RECALL 24V202 / 2024-172 REMEDY INSTRUCTIONS

Make(s): ISATA
Model(s): MANY, SEE BELOW
Model Year(s): 2023 - 2025

Concern:
The nut on the backside of the Main 12V Disconnect may have been inconsistently tightened.

FIGURE 1

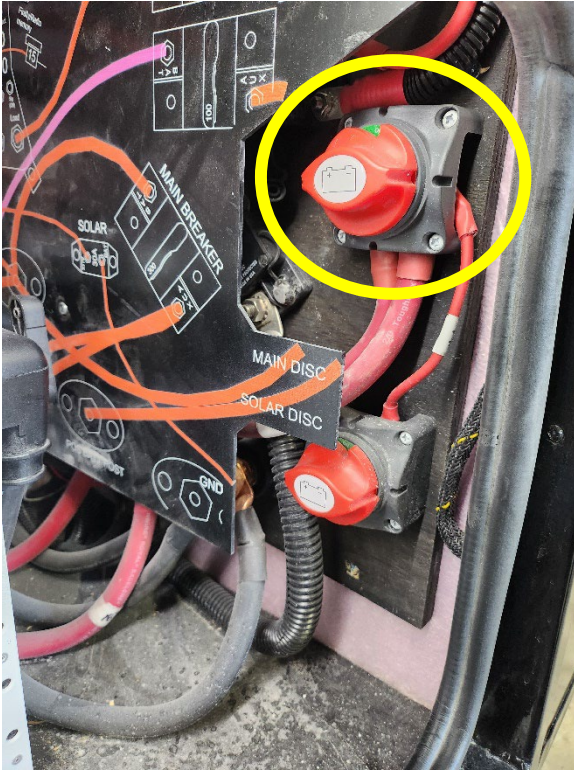
STEP 1: LOCATE THE MAIN 12V SERVICE DISCONNECT (FIGURE 1);

- REMOVE AND DISCARD THE FASTENERS, THEY WILL BE TOO LONG TO REUSE;
